Our Ref: 196/2017/02-CAG - Please quote in all correspondence.

18 October 2017

Re: 1-6 The Street, Kersey – BDC Ref B/15/01196 Highways Advice.

Figure 1: Building overhang restricts vehicle use

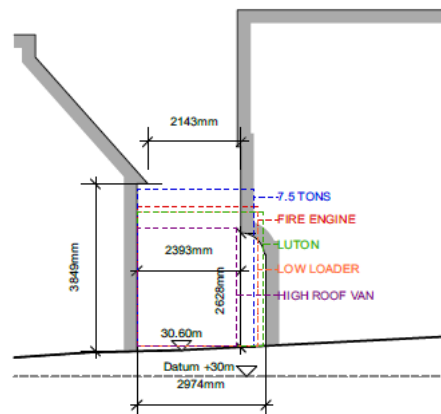
The 2017 Highways response states that the North access required a DM03 (a SCC standard access that includes for pedestrian visibility splay as well as vehicular) with entrance width 4.5m for minimum 5m set back. It goes on state that the Parking layout does not allow sufficient width at 10m set back. This is at odds with the first requirement of 4.5m width at 5m set back, to enable vehicles to pass safely in the entrance.

The southern access being approximately 3m wide does not provide sufficient width for two cars to pass. As such, although extremely lightly trafficked (accessing only two car parking spaces) *may* give rise to very occasionally a car being required to wait to allow passage of pedestrian or car.

This access could potentially provide a suitable 'out only' option (i.e. one directional), providing acceptable exiting visibility, if it was to be incorporated with an 'in only' at the northern access, to overcome the northern access visibility concerns. With single direction traffic flow and 3m width this would additionally allow for the safe passage of pedestrians, 3m being the guidance width for a driveway. A bollard would be required to protect the building over-hang for taller delivery vehicles (typically 2.55m wide). Refuse collections are proposed to be made from the road side. Due to the overhang, it would restrict the type and size of vehicle that can use the southern access, refer to **Figure 1** below, 7.5 tonnes, Fire engine and Luton vehicles could not fit. This considered option to have all vehicles leave the proposed development via the southern access is therefore not viable and not considered further.

In any event, by potentially removing one of the proposed off road parallel parking spaces nearest the Street (provided over and above SCC parking guidance requirement, for the use of No 1-6 The Street) this provides for additional width and greater set back, should this continue to be SCCs requirement (not strictly necessary given that 4.5m width at 5m setback is achieved). The proposed private drive width of approx. 4.2-4.5m is considered an appropriate width for a higher standard *shared surface road* (4.1m is the minimum). This access is therefore appropriate for two-way vehicular and pedestrian use.

Appendix F: North Access snap shot

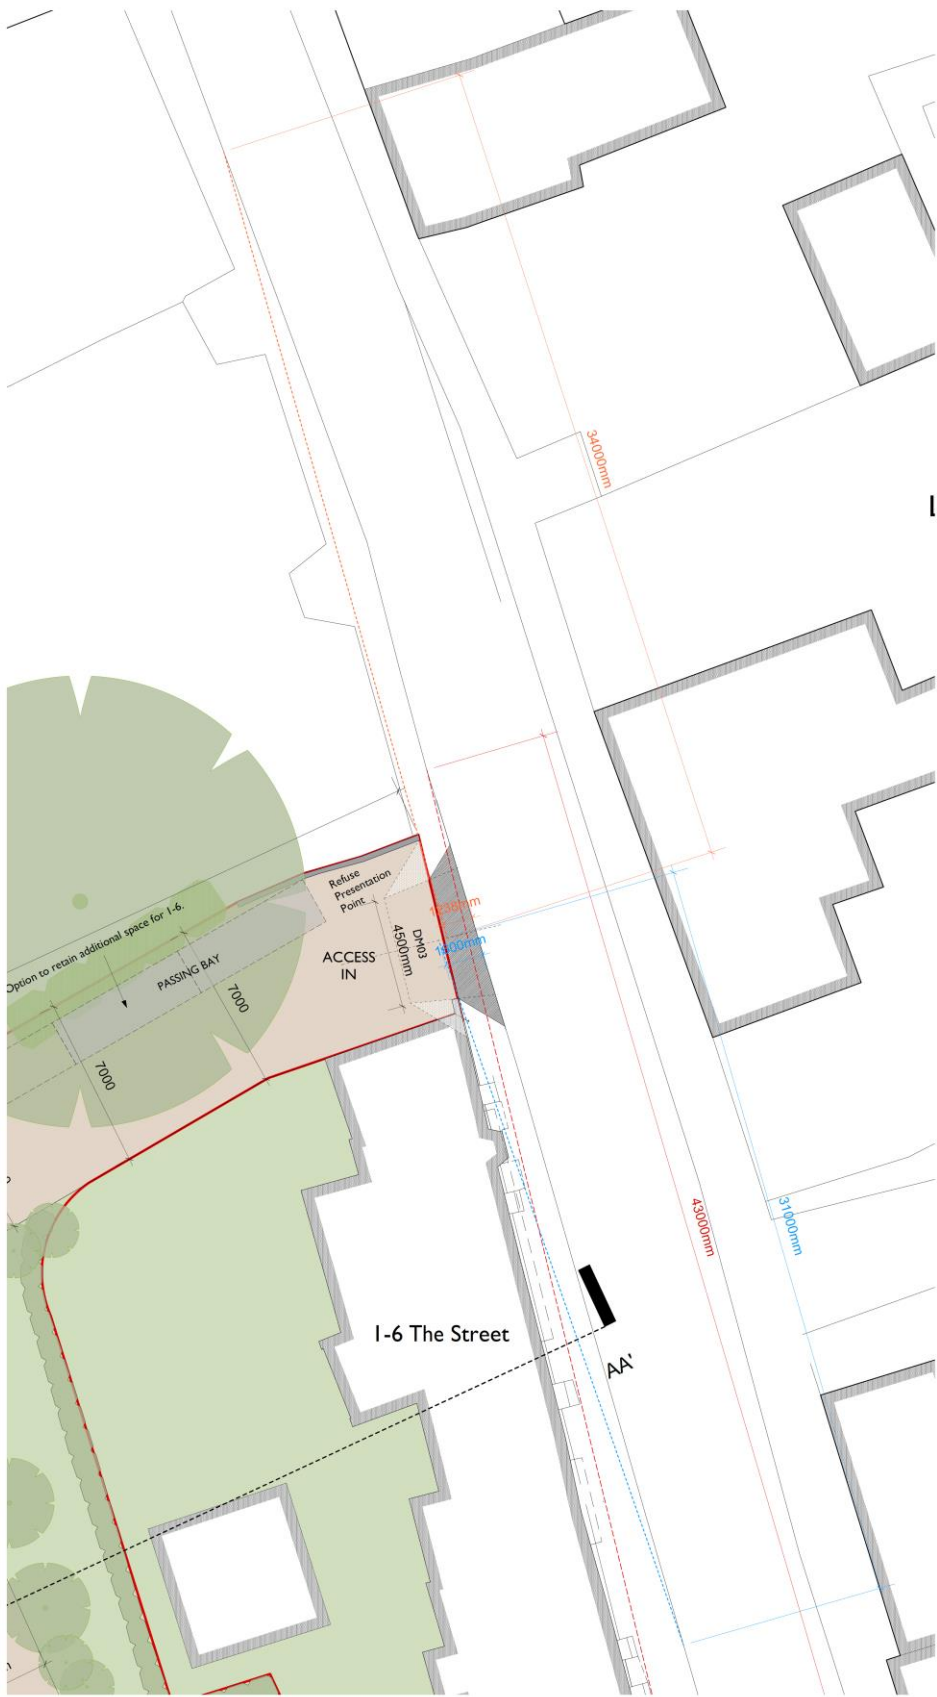
To achieve splays of 31m and 34m respectively would require the driver to be positioned approx. 1.24m back from the kerb line (to see to the *nearside* channel line, view to left) assuming the frontage red brick wall was removed, refer **Appendix F** North Access snap shot. This would require slight projection of the bonnet into the road. However, the traffic approaching the access from the left (travelling south) will be on the *far* side of the road, under normal driving conditions and thus a vehicle emerging from the northern access will be aware of this approaching vehicle ordinarily *before* reaching 1.24m set back. In addition, the evidenced, very low peak hour, traffic flow demonstrates that the *frequency* of residual risk as a result of this would be low. Consideration could be given to the addition of white 'H' markings at the access to also provide some protection from obstructive on street parking.

The ATC data has provided evidence for this site being a very lightly-trafficked and slow speed location. The required 2 x 31m and 2x 34m visibility splays can be achieved at the existing southern access and could be significantly improved at the existing northern access with the red brick frontage wall demolition and removal of on street parking. To achieve 31m and 34m splays at the northern access requires the driver to be positioned at 1.24m set back, to see to the *nearside* channel line, view to left. The front of some vehicles will protrude slightly into the running carriageway of The Street. However, the traffic approaching the access from the left (travelling south) will be on the *far* side of the road, under normal driving conditions and thus a vehicle emerging from the northern access will be aware of this approaching vehicle ordinarily *before* reaching 1.24m set back. In addition, the evidenced very low peak hour traffic flow demonstrates that the *frequency* of residual risk as a result of this would be low. Consideration could be given to the addition of white 'H' markings at the access to also provide some protection from obstructive on street parking.
